**Variance #851-21-000312-PLNG: Bauer
Administrative Decision & Staff Report**

Decision: Approved with Conditions as Modified
Decision Date: March 22, 2022
Report Prepared By: Sarah Absher, CFM, Director

Request: Reduce required twenty (20) foot front-yard setback to eleven (11) feet for the construction of a new single-family dwelling to replace an existing single-family dwelling on a property located within the Unincorporated Community of Neskowin (Exhibit B).

AREA MAP

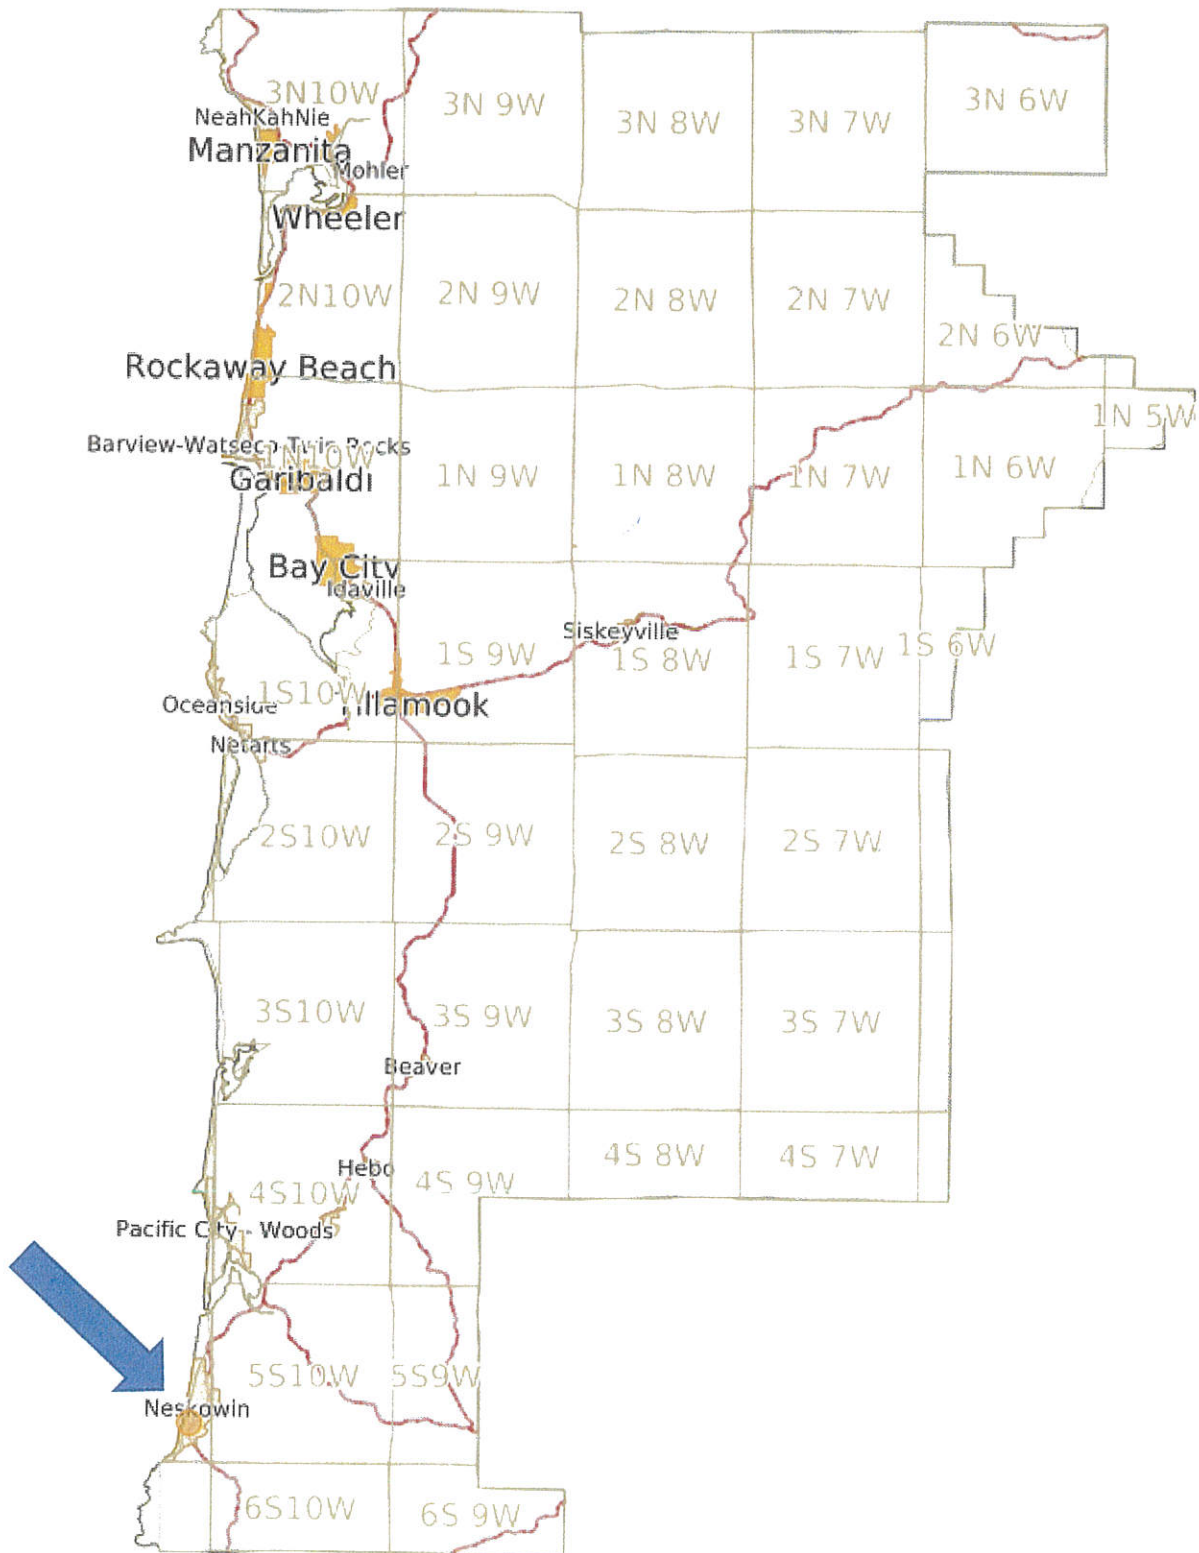
As depicted on the vicinity map included in "Exhibit A", several dwellings are sited within current front and/or rear property line setbacks; on the north side of Sheridan Avenue, four out of seven properties have dwellings that appear to be at or across the front yard property line setback requirement and are encroaching into the right-of-way (ROW).

Application of the setback exemptions under TCLUO Section 4.110 allow for a maximum 30-foot-deep building footprint. In review of the size of building footprint depths within the vicinity, Staff also finds that several building depth footprints exceed 30-feet (Exhibit A).

Site Plan

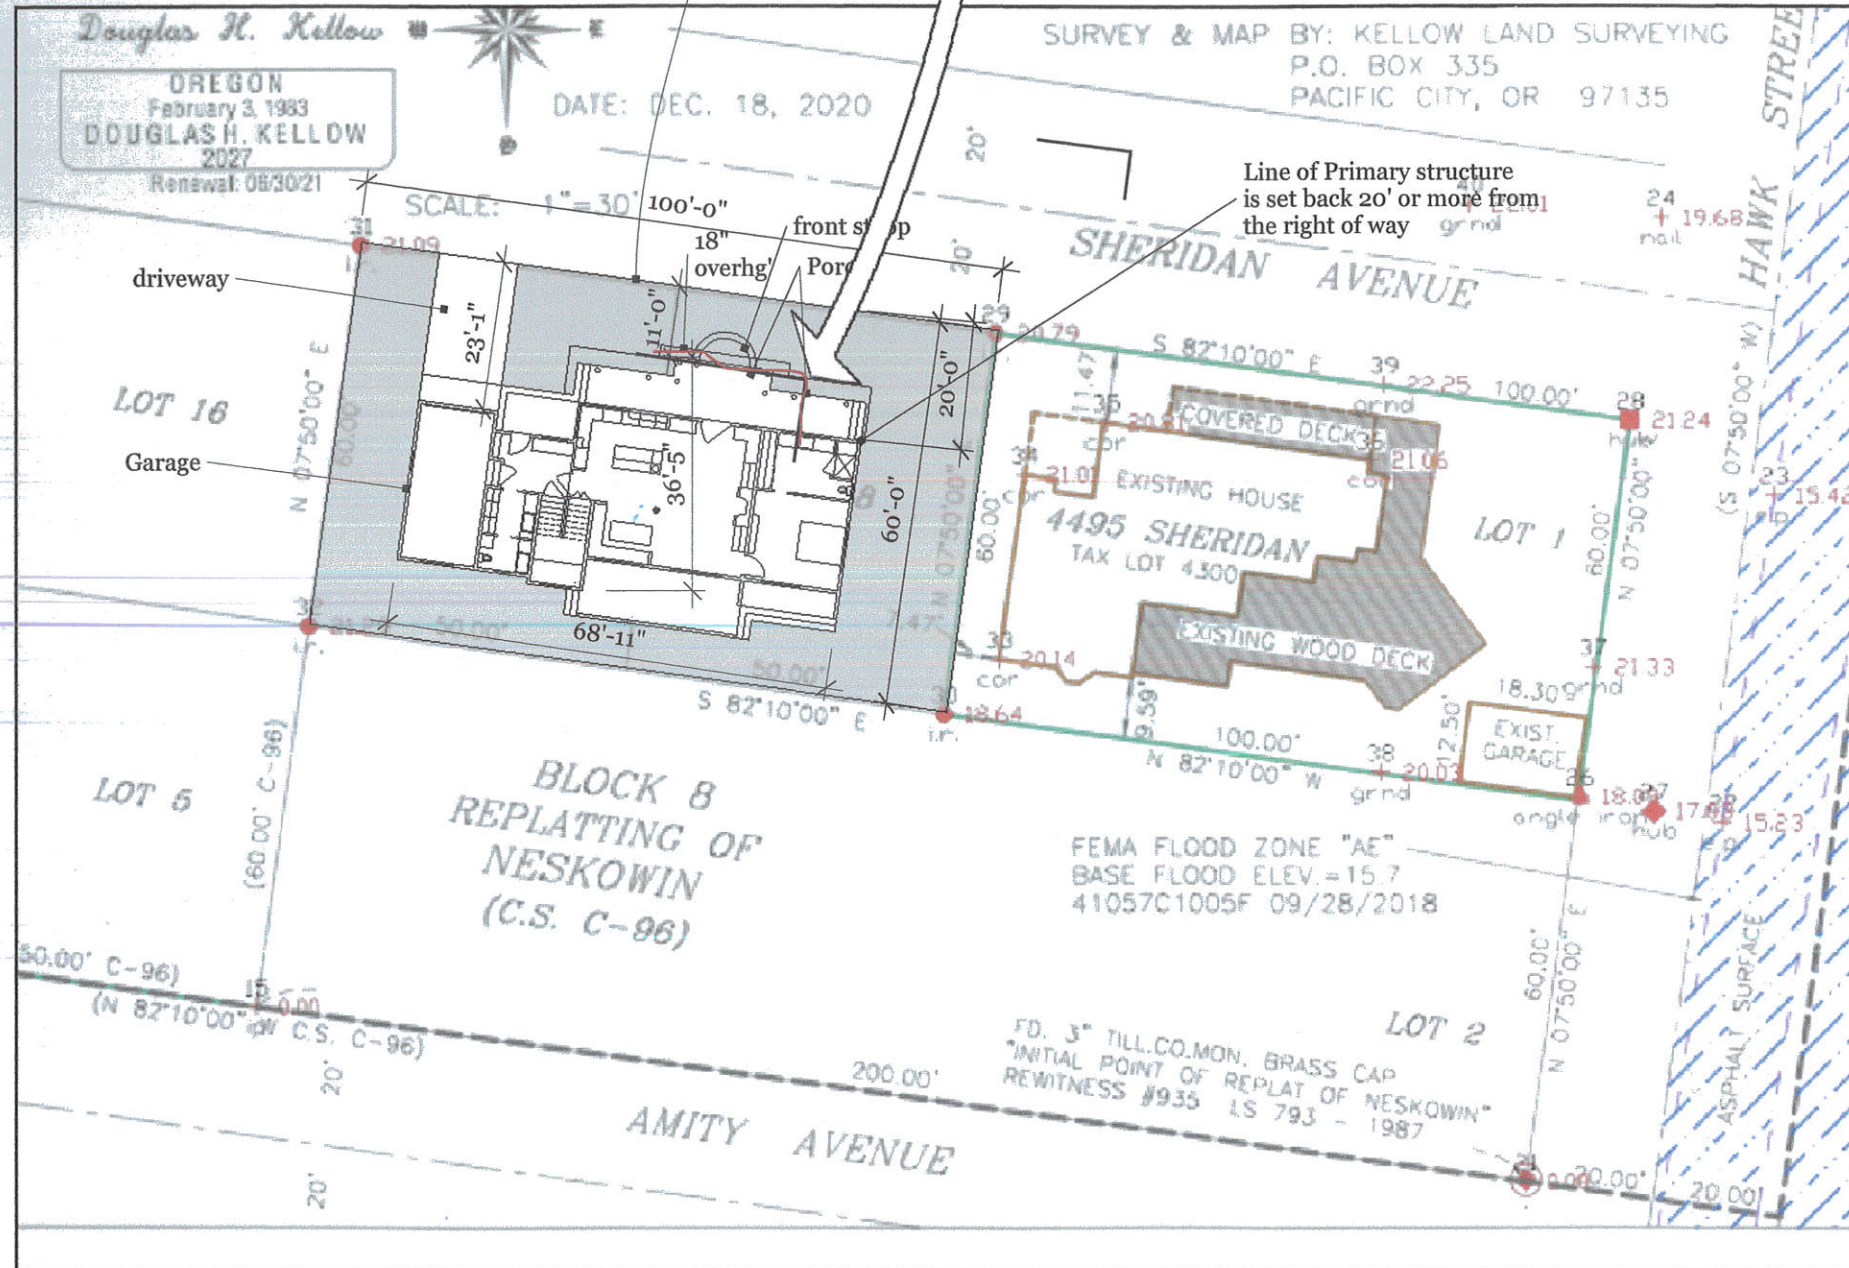
Specifically, the response to section 8.030 #4 is simply "none". This criteria needs to be fully addressed by the applicant and should clarify precisely why there is no reasonable alternative. Reducing the size of the proposal so that it can be located on the property in compliance with current code may be reasonable.

Variance request
The variance request to the front yard setback is to allow for a front porch with a 11' setback along Sheridan ave.

It is not clear to us from the drawing submitted whether the setbacks proposed on the sides and front align with the properties on either side.

“I’m sending a revised site plan with a reduced front porch and overhang. This compromise will ensure that the proposed porch with it’s overhang will be further from the right of way than the existing house. This and other measures are intended to be an improvement to the existing conditions” (Exhibit B).

In response to the comments received by the Tillamook County Public Works Department, the site plan was modified to maintain the 11-foot front yard setback, confirming that access to adjacent properties will not be impacted by the proposed front and rear yard reduction and that driver visibility will not be obstructed (Exhibit B).

Staff finds the proposed Variance for an 11-foot front yard setback is reasonable given the size of the property and the established development pattern in this vicinity. The Variance request is limited to the front yard setback and the site plan demonstrates all other applicable setback and lot coverage standards will be met (Exhibit B). Staff also finds the Variance request is reasonable as the request is consistent with the established front yard setback historically maintained on the property (Exhibit B).
